Integrated Device Technology, Inc.
6024 Silver Creek Valley Road, San Jose, CA - 95138

PRODUCT/PROCESS CHANGE NOTICE (PCN)

PCN #: Q1703-02 DATE: 2-May-2017 Product Affected: F1423NBGI(8) Date Effective: 2-Aug-2017	MEANS OF DISTINGUISHING CHANGED DEVICES: <input type="checkbox"/> Product Mark <input type="checkbox"/> Back Mark <input type="checkbox"/> Date Code <input checked="" type="checkbox"/> Other Materials used is traceable through Assembly Lot#
--	---

PCN Type: Change of Die Size

Detail Of Change:

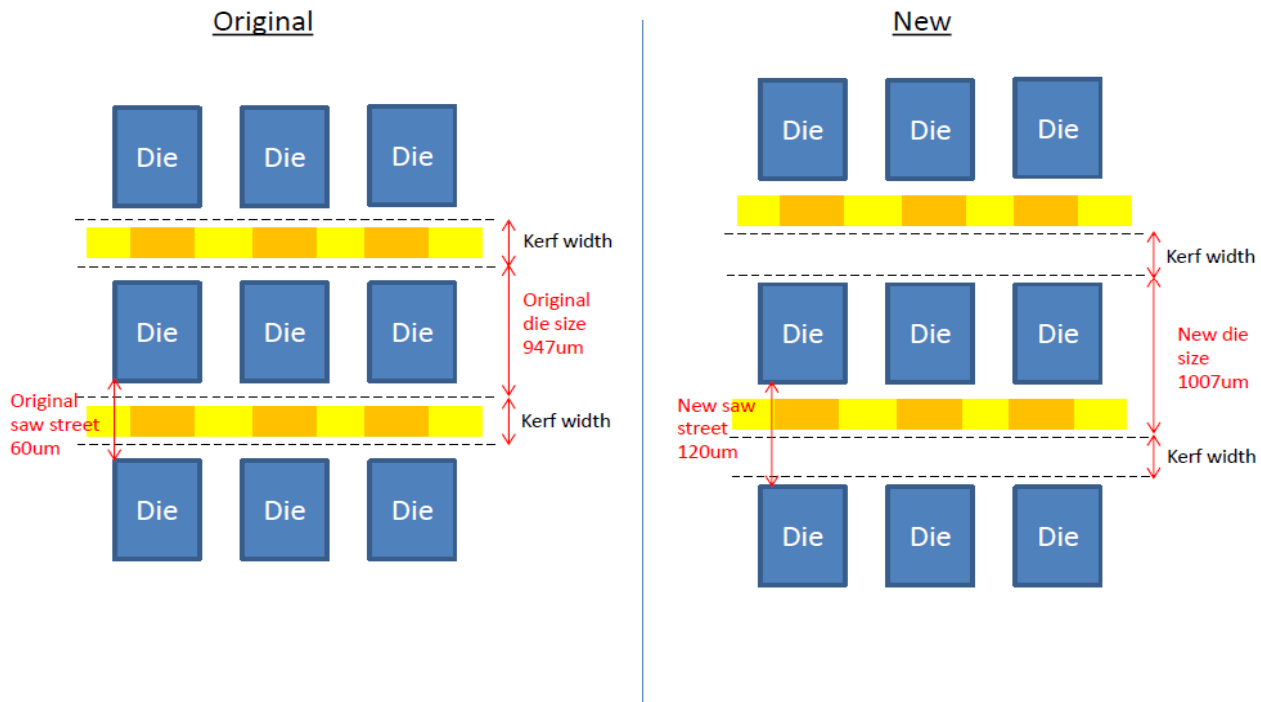
This notification is to advise our customers that select IDT parts are being converted to a 530um x 1007um die size from a 530um x 947um die size as a result of the increased to the saw street width dimension. This change is being made to improve manufacturing capability. Refer to the below illustration.

There is no change to the product design or process technology.
There is also no change to the package, backend manufacturing process or the the data sheet and ordering part number.
